Product Change Notification

Change Notification #: 111622 - 01
Change Title: Intel(R) Server System P4000CP, PCN 111622-01, Product Design, Product Design, BIOS and ME Firmware Update, Reason for Revision: Add P4308CP4MHGC and P4208CP4MHGC
Date of Publication: November 16, 2012

The picture below shows the stand-off pre-installed on the server board:

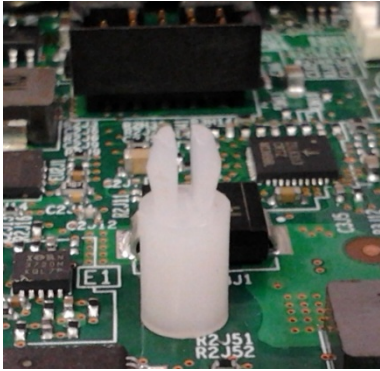
1. The BIOS is being updated from revision 01.01.0001 to 01.02.0005, and the Manageability Engine (ME) firmware is being updated from revision 02.01.05.069 to 02.01.05.091. Please see Technical Advisory TA-0996 for more information.
2. A plastic stand-off will be pre-installed on the server board. Users can install an eUSB SSD device on the stand-off.
